TECHNICAL SERVICE BULLETIN 10044

MODEL(S): 150GTL, 200GTL

DESCRIPTION: Reduced adjacent channel rejection when the Noise Blanker is on.

150 GTL

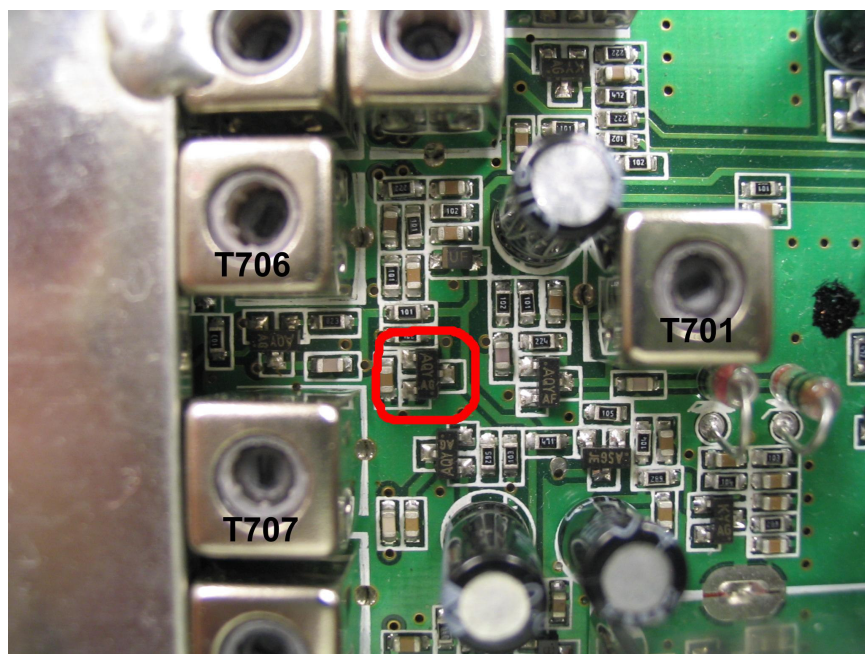
ACTION: Place a 220pF capacitor between base-emitter of Q3. The location and pinout of Q3 is shown on the following pages.

200 GTL

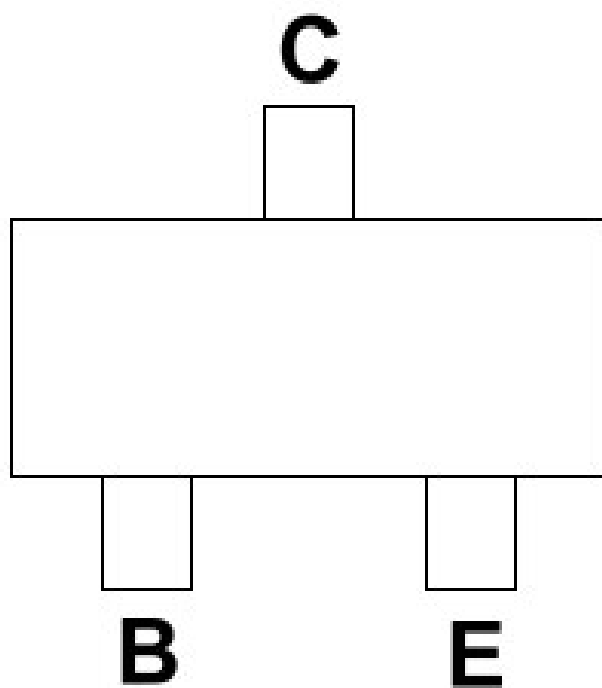
Q3
